Design and Access Statement - Addendum

Centre Heights

Swiss Cottage

October 2015

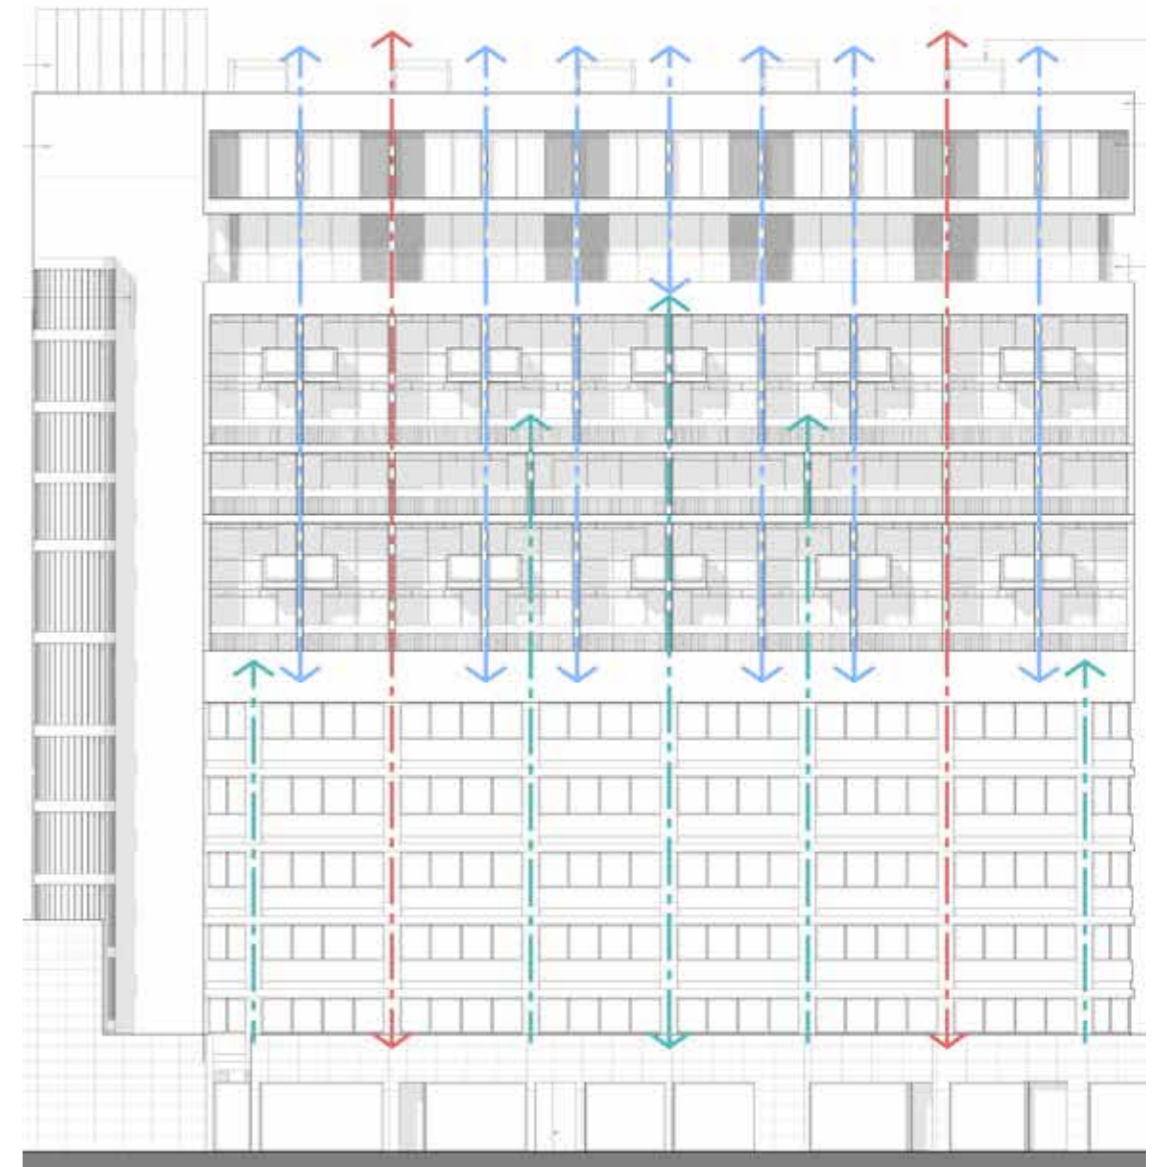
Comments have been received from Officers and from the Conservation Area Advisory Committee relating particularly to consideration of the grid generated by the existing building and the intention of the proposals to create an interlocking structural grid that meshes the new extension with the existing building. Emphasis has also been drawn by Officers and the CAAC to the structural bays of the existing building.

Officers have expressed concern at the potential impact of the lanterns on improving the profile of the building.

Following discussions with officers, we have revised the proposals to accentuate certain vertical elements, in order to further connect the upward extension with the vertical grid generated by the existing building, as illustrated in the adjacent diagram showing the principles of the interlocking structural grids.

On the front elevation an additional fin has been introduced at the upper level so that each unit is sub-divided into 2 structural bays, responding to the distinctive gridlines generated by the residential component beneath (floors 6-10). The line of glazing at this level still aligns with the glass plane of the former office component beneath (floors 1-5) and aids in tying in the ribbon like nature of the glass plane at this level with the corresponding ribbon like windows of the former office component beneath.

The design of the new parapet has been altered and increased in height slightly to 'cap' the upper storey, providing a strong top to the building, following the language of the existing building and the existing parapet height above the 10th floor. This has enabled the removal of the previously proposed glass balustrade at roof level thus defining more clearly the edge of the building in a manner more akin with the existing building.

The principal of the façade design and massing remains the same, to create a set-back at the lower level in order to articulate a visual separation between the new extension and the existing building. The glass plane at the lower level still aligns with the glass plane of the residential component below (floors 6-10), however the depth of the fins have been increased to further emphasize the primary

The design of the lanterns has been reviewed and tested to ensure these respond better to the vertical grids.

Proposed new locations of existing telecommunications masts

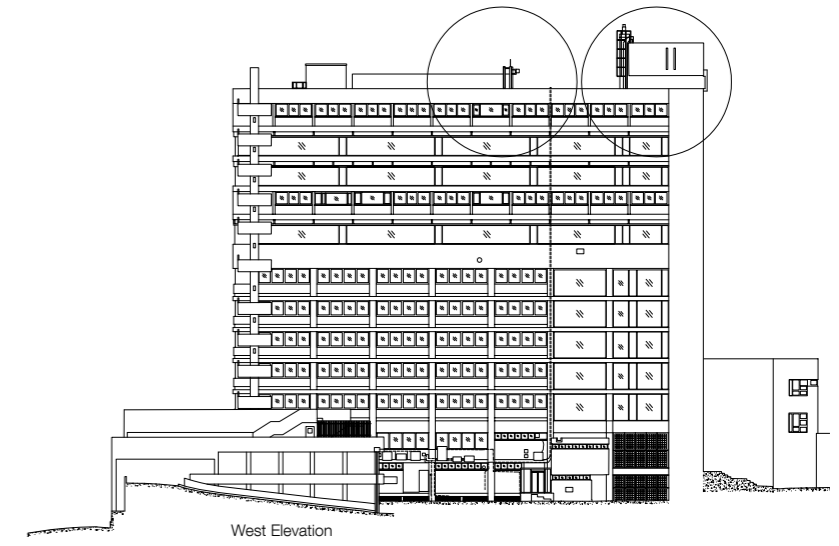
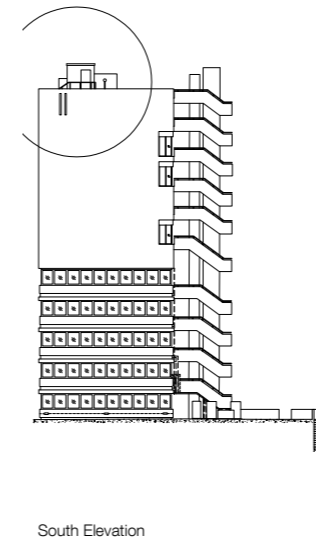
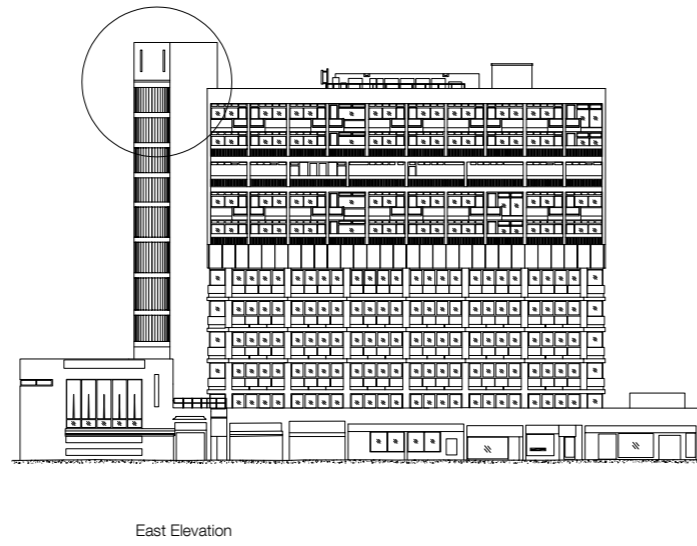
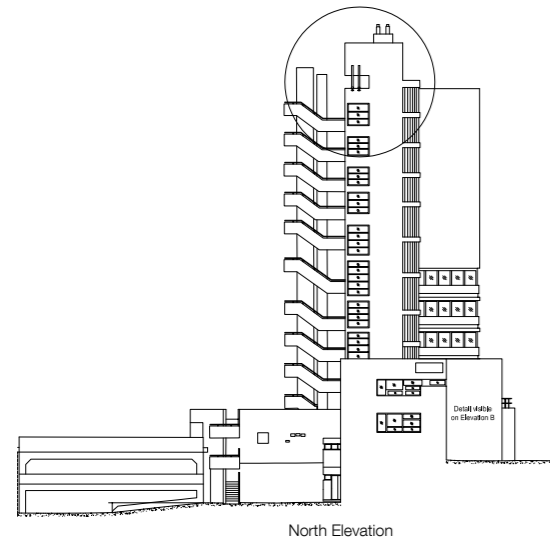
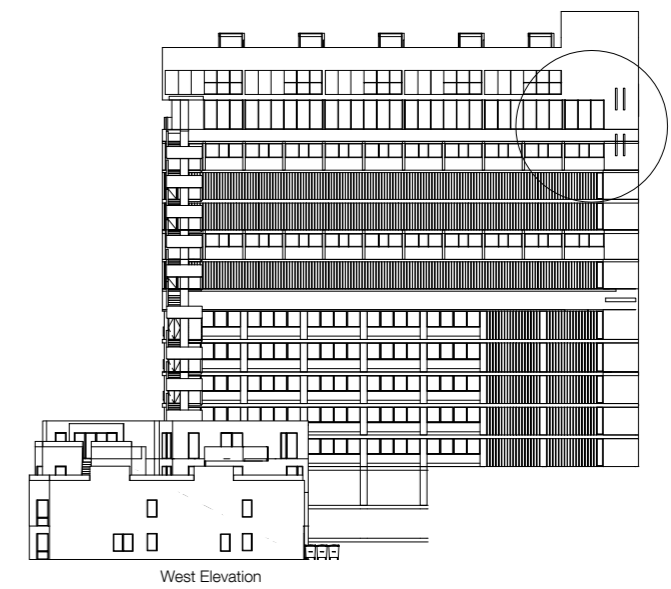
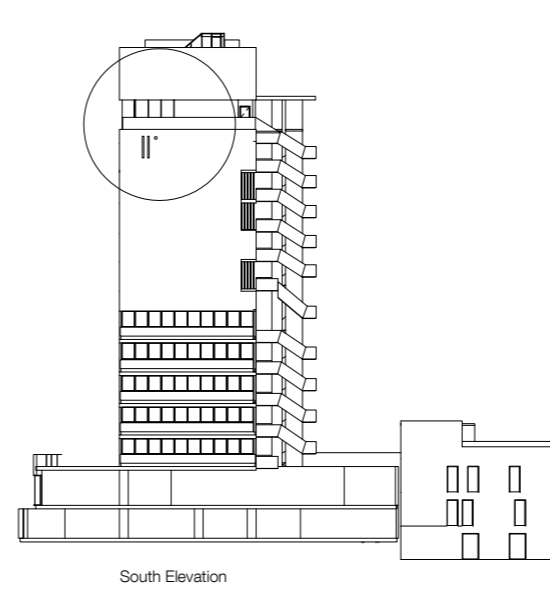
Officers requested the revised positions of the telecommunications masts be shown on the proposed elevations; the elevations on the adjacent page identifies the existing locations as previously and proposed, on updated elevations. These are also shown on the application drawings.

The current telecommunications masts situated at parapet and roof level will be re-positioned on the building at the current roof level adjacent to the services void between 10th and the new 11th floor. These will be discreet modern fittings, painted to match the concrete walls.
